26 October 2016

Our Ref: 142580

**RE: BCA COMPLIANCE CAPABILITY STATEMENT
UNSW BIOLOGICAL SCIENCES STAGE 2 SECTION 96 APPLICATION**

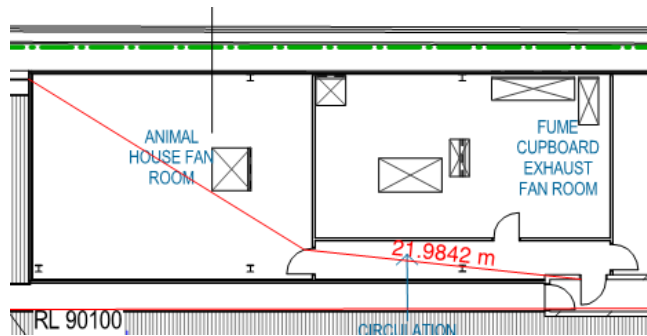
- 2.6 Complying egress from the Ground Floor of the south west part of D26 and the Biolink relies on access being available into the western fire isolated stairway. A design change is required to provide for this access. Depending on the location of the access door there may still be a travel distance non-compliance from the D26 south west plant room which may be up to 24 m to a point of choice.

Egress from the Building D26 level 8 Animal House fan room is 22 m to a point of choice.

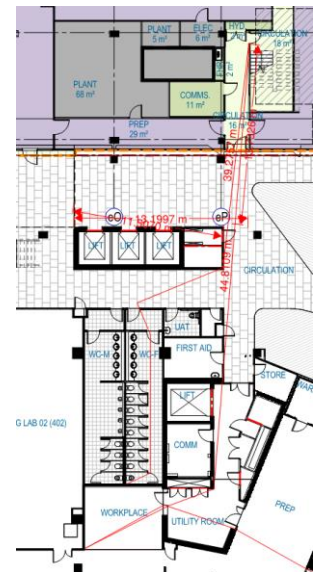
2.7 The exits serving Building E26 have been redefined. This causes the following additional travel distance issues (performance justification required):

- (a) Distance from the GF toilets in the Biological Sciences Building E26 are 39 m the nearest exit (D26 east exit stair).
- (b) If Biological Sciences Building E26 utility room G009 and workplace G004 does not have access via prep room G005 in an emergency, travel distance to the nearest exit is 45 m to D26 east exit stair.

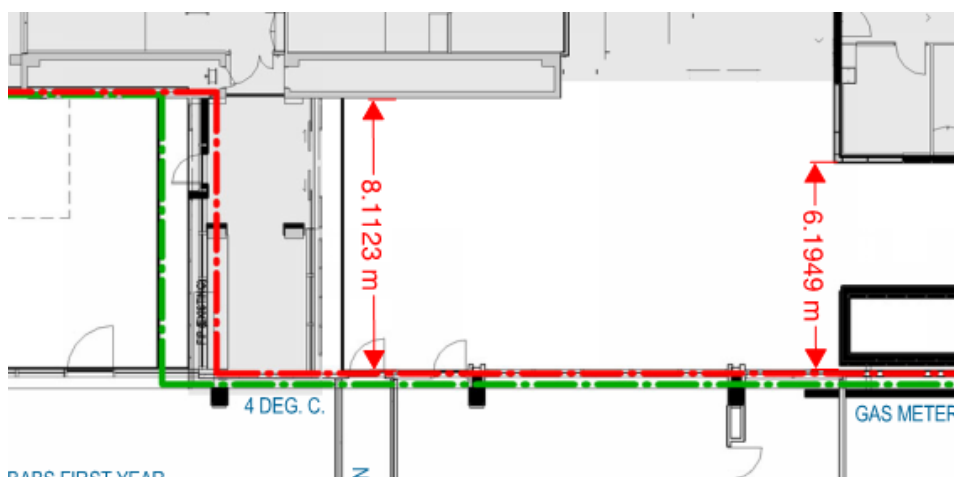
2.9 The west stair connecting Building D26 Level 7 to Level 8 does not comply as follows:

- (a) is not a fire isolated stair (BCA D1.3).
- (b) does not discharge to the outside (BCA D1.7)
- (c) is less than 1 m wide (BCA D1.6)
- (d) goings and risers comply with AS1657 in lieu of BC D2.13.

(e) balustrades comply with AS 1657 in lieu of D2.16.
